ISSUED FOR SECTION 4.55

PROJECT:
OPAL GLENMORE PARK
FLORIBUNDA AVENUE, GLENMORE PARK, NSW 2745

DRAWING TITLE:
LOWER GROUND FLOOR PLAN

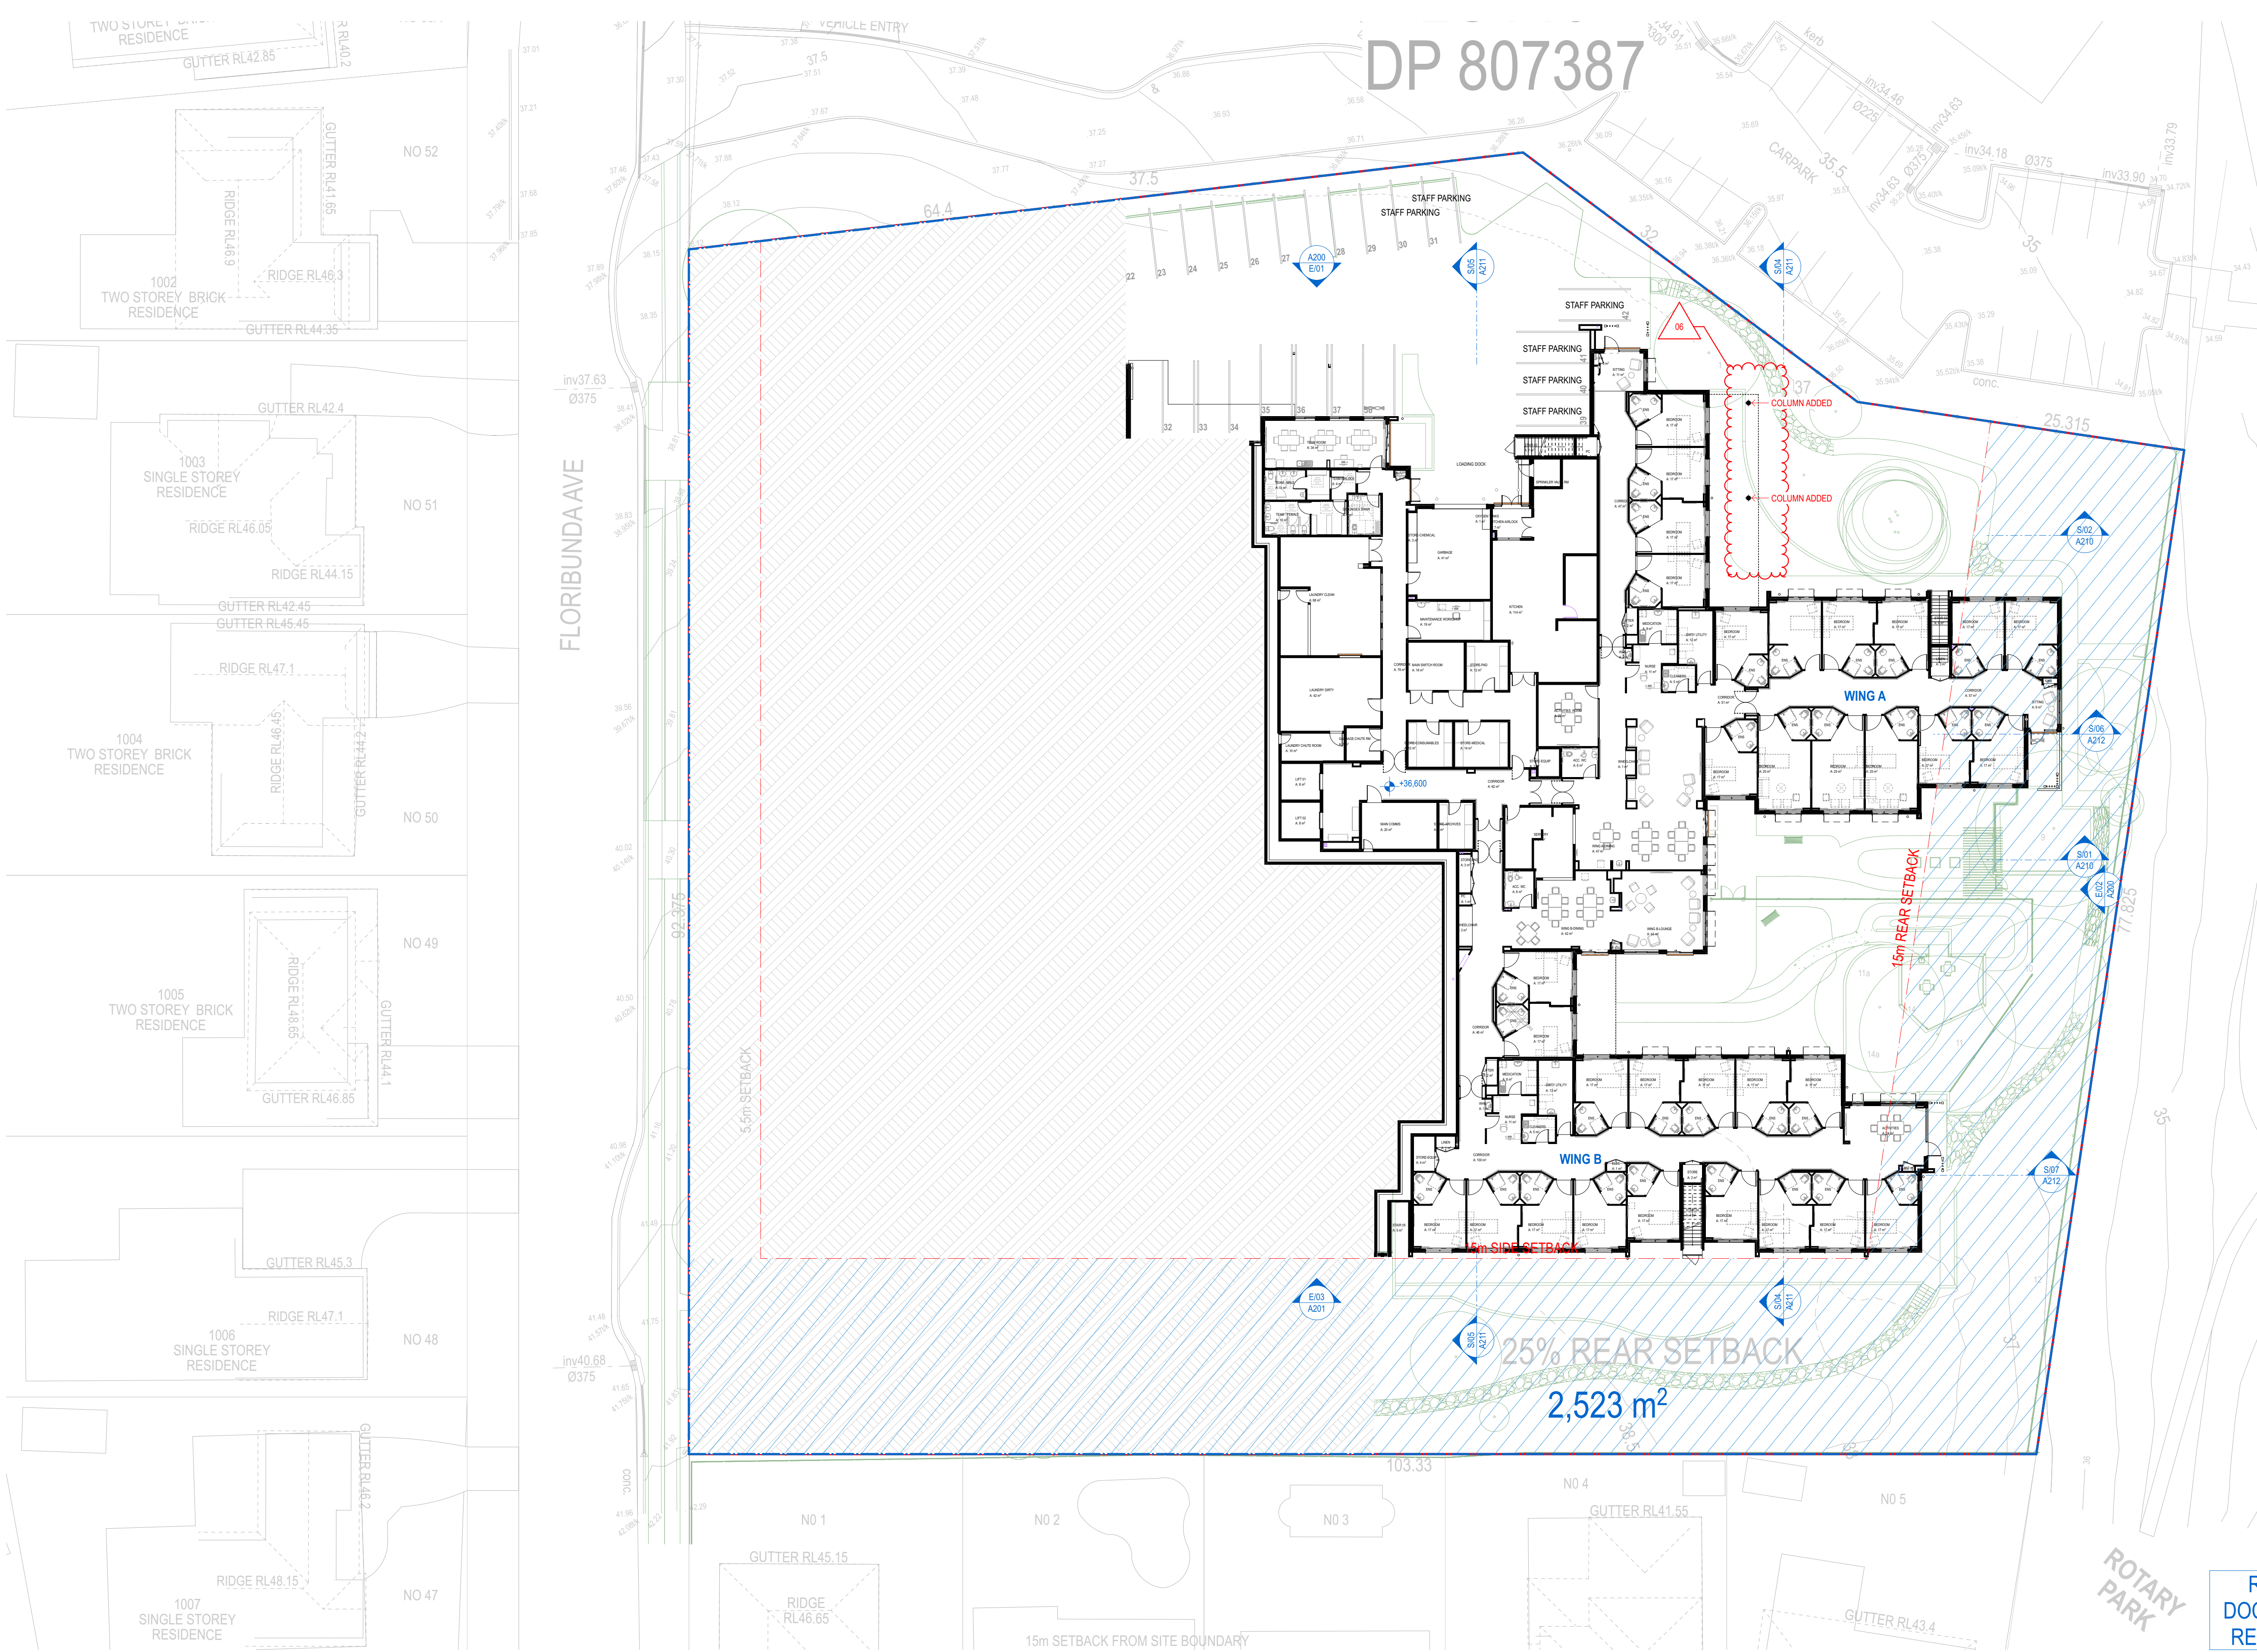
PROPOSED NEW BALCONY	06	28/9/20
DRAWING REVISIONS	CH	DATE

DRAWING TITLE:
ELEVATIONS

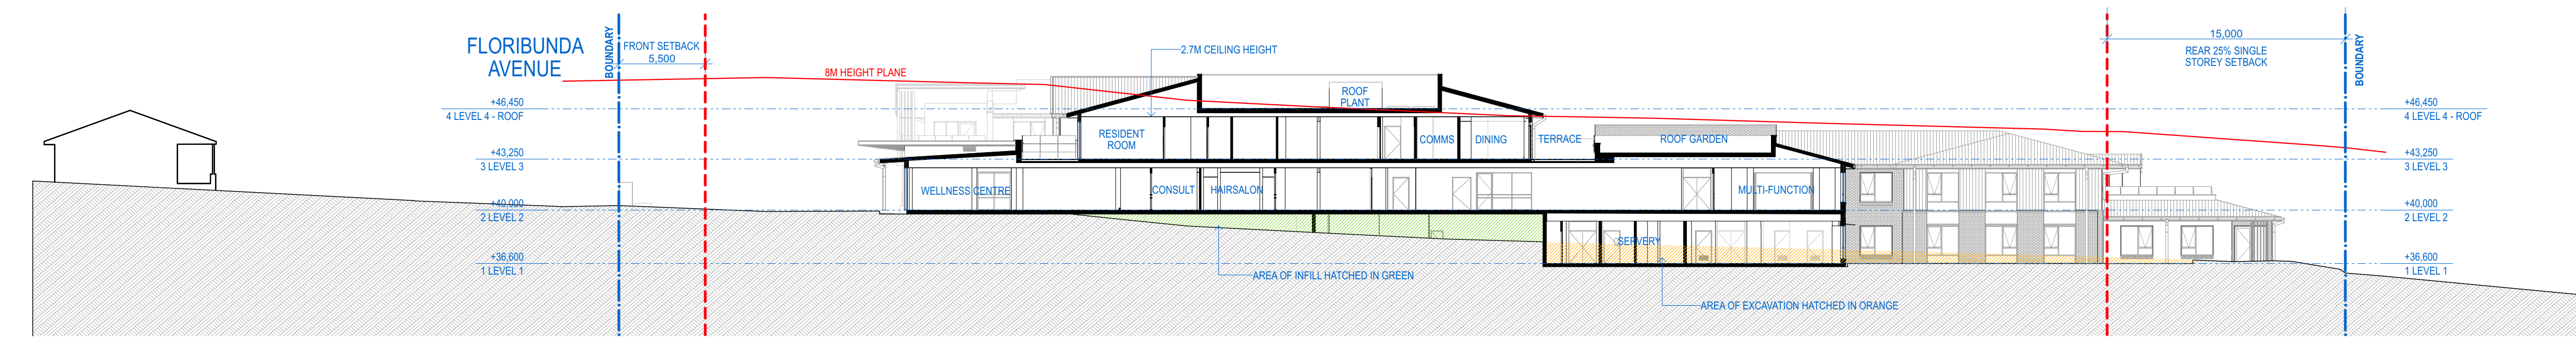
PROPOSED NEW BALCONY		06	28/9/20
DRAWING REVISIONS		CH	DATE
ISSUED FOR SECTION 4.55		D	CFA
DATE		DESCRIPTION	REV
		DRAWN	CHECK
		REV	CHECK

PROJECT:
OPAL GLENMORE PARK
FLORIBUNDA AVENUE, GLENMORE PARK, NSW 2745
DRAWING TITLE:
SECTIONS

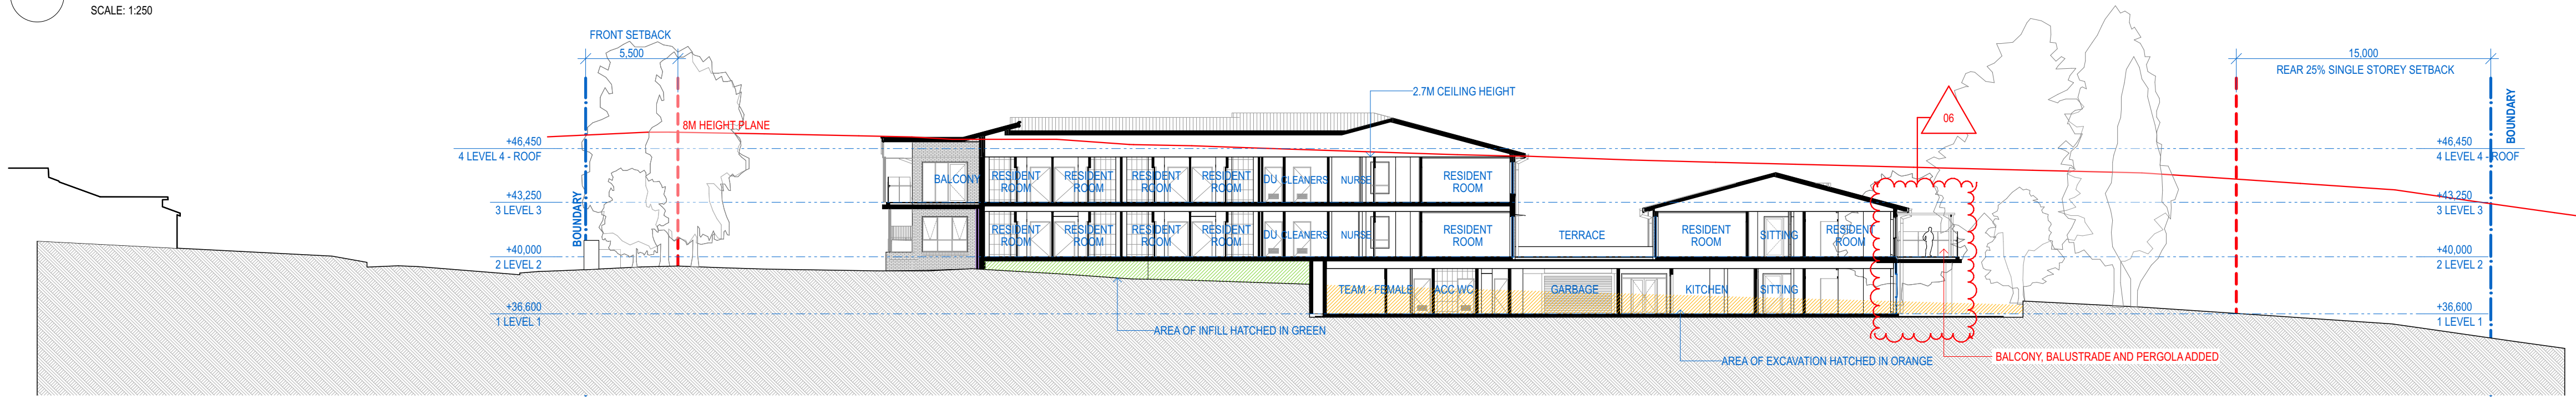
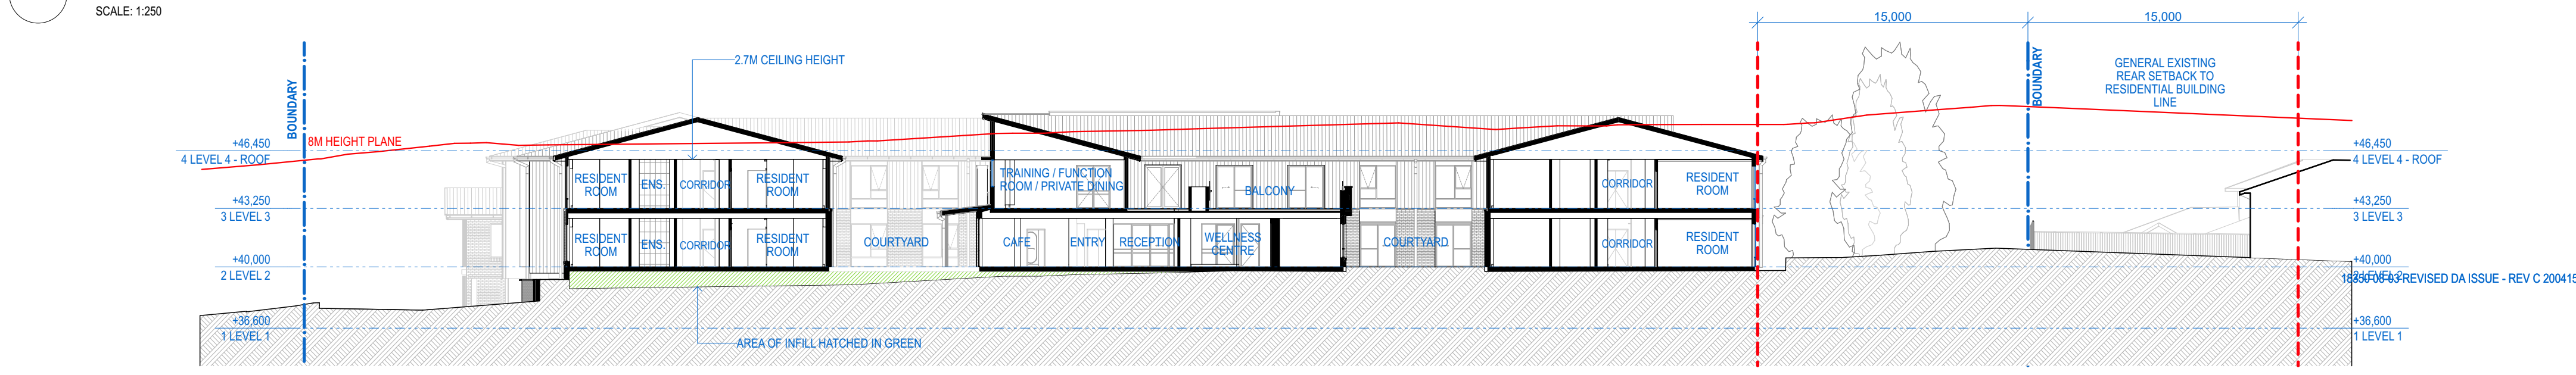
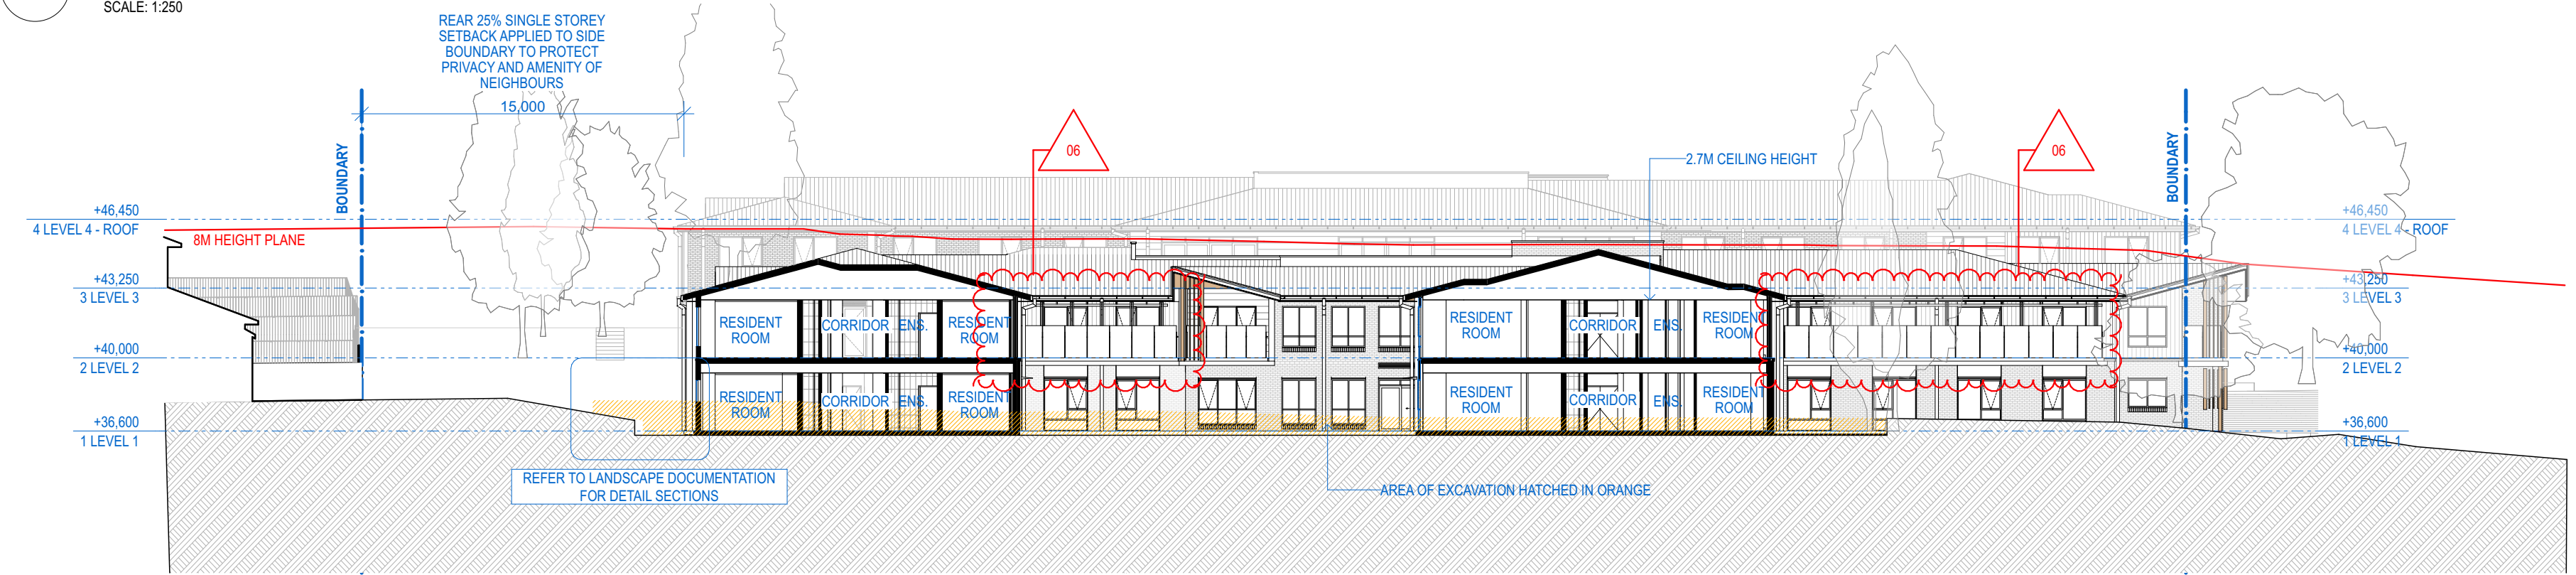
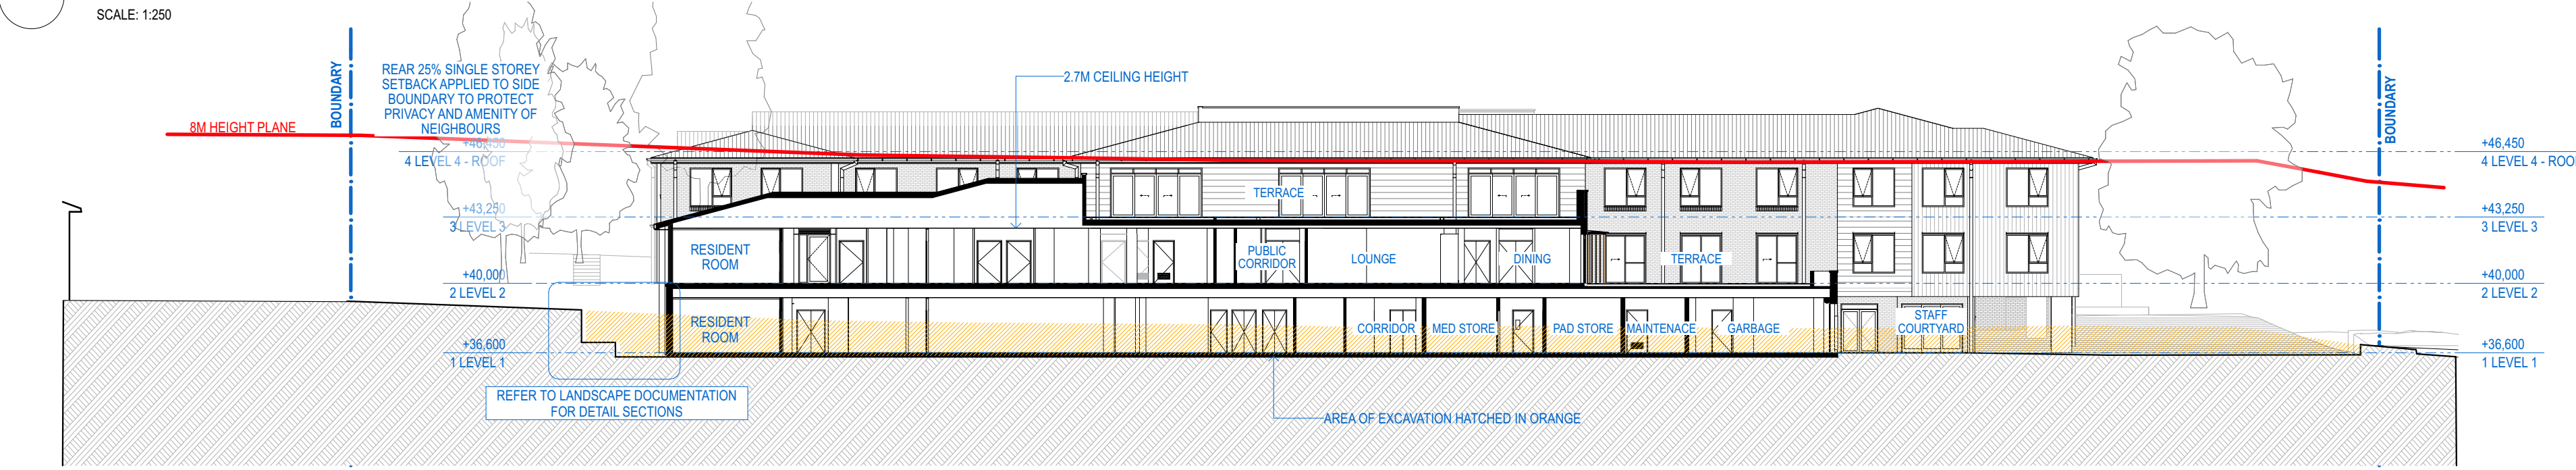
PROPOSED NEW BALCONY		06	28/9/20	28/9/20	ISSUED FOR SECTION 4.55	C	CFA	BW
DRAWING REVISIONS		CH	DATE	DATE	DESCRIPTION	REV	DRAWN	CHECK
